Technical Service Information

THM 4L60 (700-R4)

NO WIDE OPEN 3-4 SHIFT (POLICE ONLY)

Figure 1

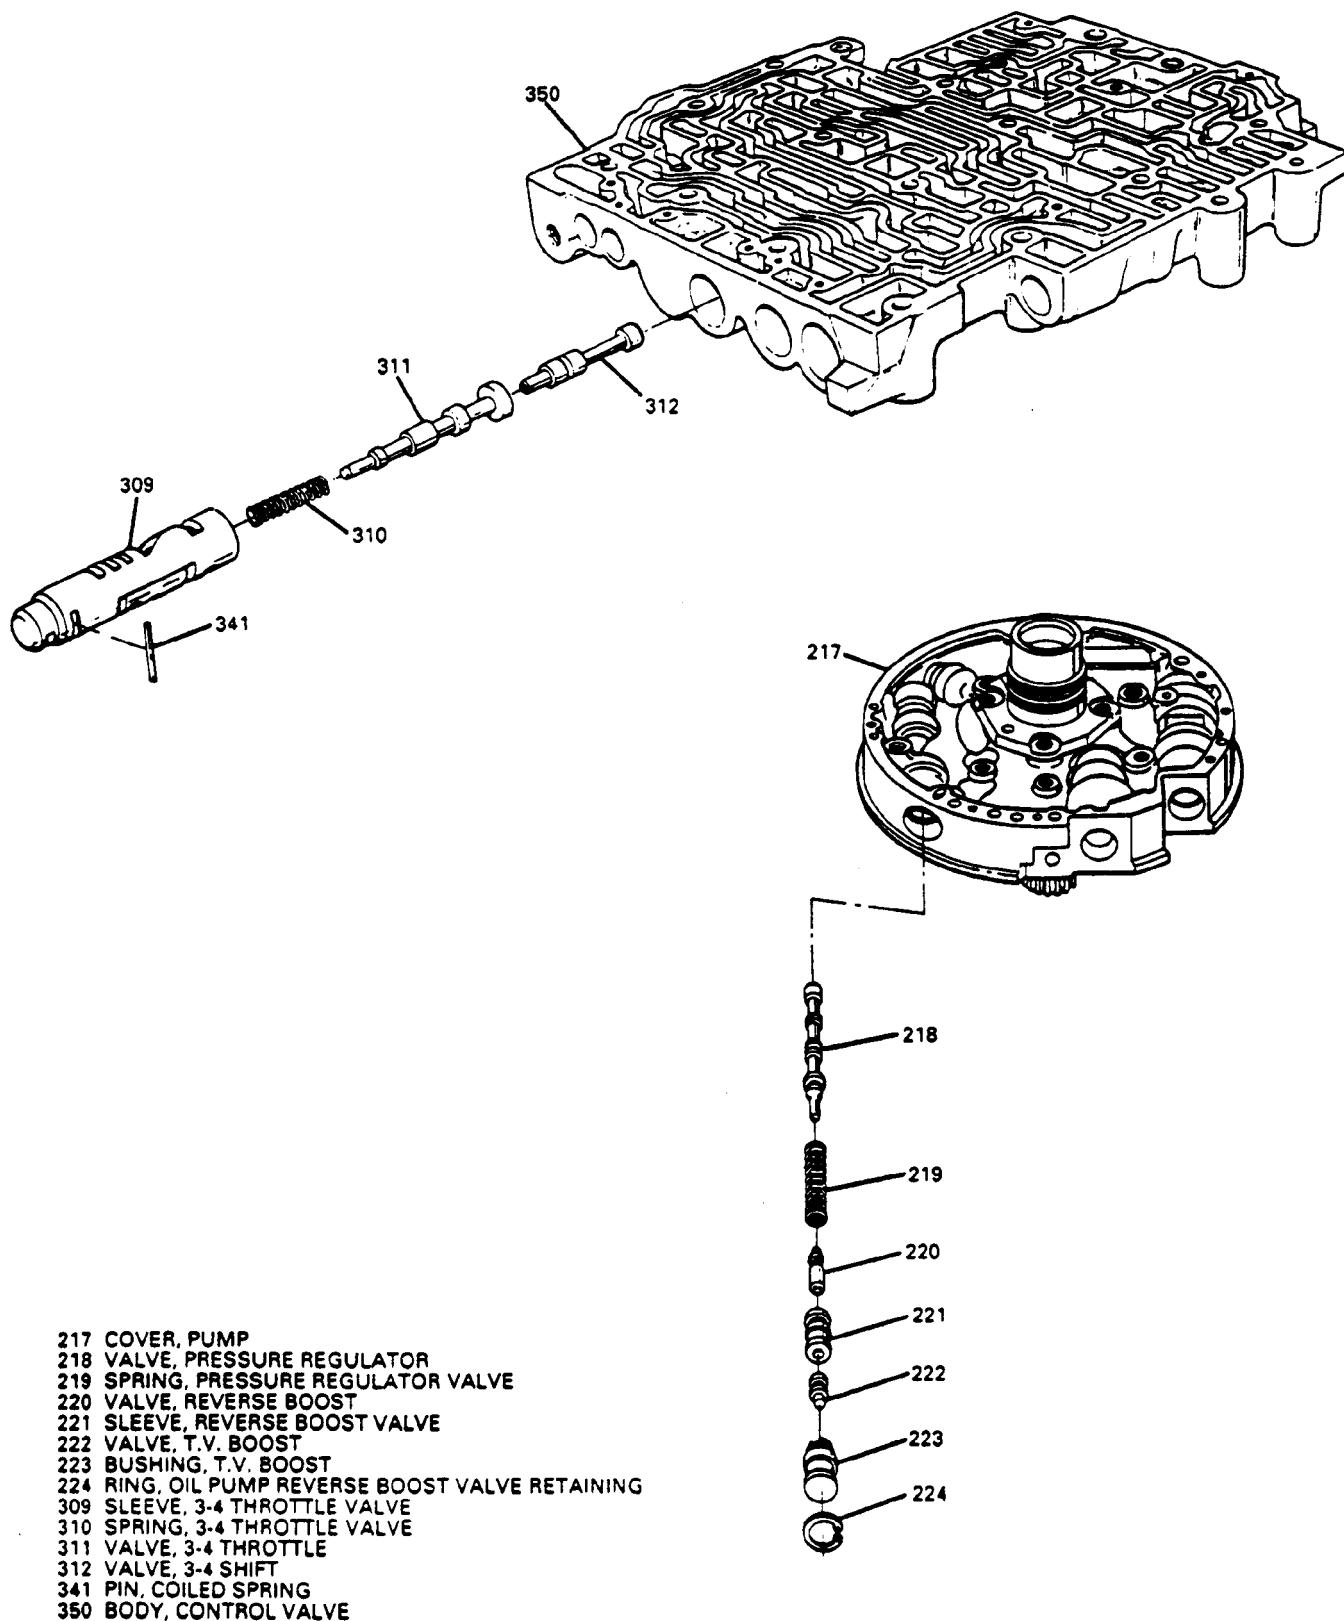
COMPLAINT: Some 1989-1991 Police vehicles with the 5.7L engine, may experience a loss of wide open throttle 3-4 upshift when hot. The models affected are 9YNM, OBPM, 1BFM.

CAUSE: Wrong transmission calibration. An updated transmission calibration has been released to address this condition.

CORRECTION: Install the updated transmission calibration, contained in service package 8673948, which includes the following:

(1) T.V. Boost Valve and Bushing.

(2) 3-4 Throttle Valve, Bushing, and Spring.

Install the new T.V. Boost Valve and Bushing into the pump cover as shown in Figure 1.

Install the new 3-4 Throttle Valve, Bushing, and Spring into the valve body assembly as shown in Figure 1.
